# UNITED STATES PATENT AND TRADEMARK OFFICE

APPLICATION NO.	FILING DATE	FIRST NAMED INVENTOR	ATTORNEY DOCKET NO.	CONFIRMATION NO.
10/562,491	08/18/2006	Hans-Jurgen Hannig	LSP-8	8304
20311	7590	12/12/2007	EXAMINER	
LUCAS & MERCANTI, LLP 475 PARK AVENUE SOUTH 15TH FLOOR NEW YORK, NY 10016				FONSECA, JESSIE T
ART UNIT		PAPER NUMBER		
		3633		
MAIL DATE		DELIVERY MODE		
		12/12/2007		
		PAPER

<b>Office Action Summary</b>	<b>Application No.</b>	<b>Applicant(s)</b>
	10/562,491	HANNIG, HANS-JURGEN
	<b>Examiner</b>	<b>Art Unit</b>
	Jessie Fonseca	3633

## DETAILED ACTION

Fig. 22: Palmberg (US 2003/0009971 A1)

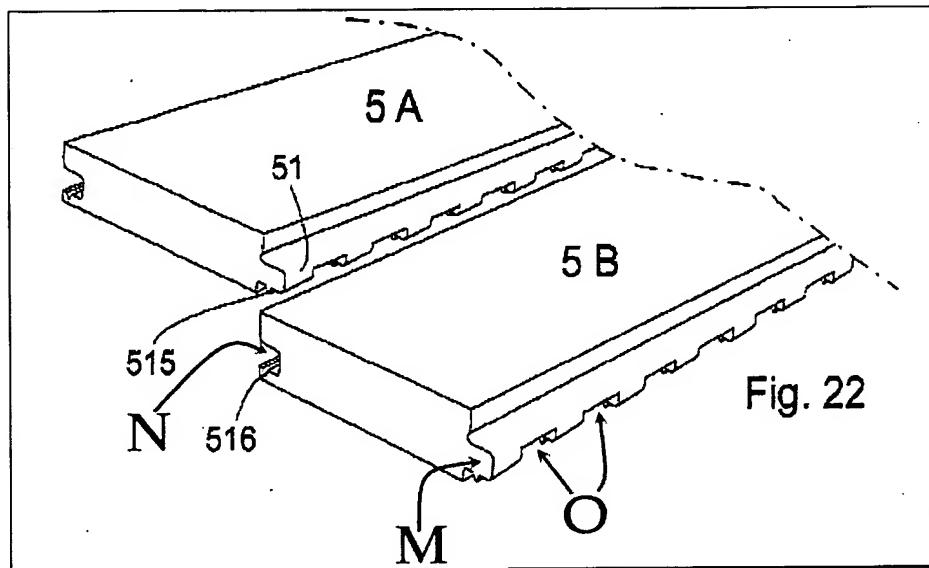
With regards to claim 8: Palmber discloses a panel comprising a quadrangular panel portion (3A) of wood material (figs. 11 – 14; par. 0035), wherein mutually opposite edges of the panel (3A) have mutually complementary positively locking profiles (M, N) so that similar panels can be assembled, and wherein the surface of at least one of the positively locking profiles (N) has at least in region-wise manner raised portions (515) and recesses (O) (figs. 19 and 22), characterized in that the raised portions (515) is provided with an overdimension.

It is noted that the overdimension is capable be ground away by friction during assembly of two panels and that the recesses are of a volume in which resulting abrasion particles from the raised portions can be received.

With regards to claim 9: Palmber further discloses the positively locking profile (N) is in the form of a groove profile with an undercut configuration and the oppositely disposed positively locking profile (M) is in the form of a tongue profile with an undercut configuration (fig. 19- 22).

With regards to claim 10: Palmber further discloses the raised portions (515) and recesses (O) are provided on the tongue profile (M) and the groove profile (N) has a smooth surface (figs. 21- 22). The smooth surface of the grooved

With regards to claim 11: Palmber further discloses the raised portions (515) and recesses (O) are arranged at a tongue (M) underside which is capable of facing towards a laying surface.
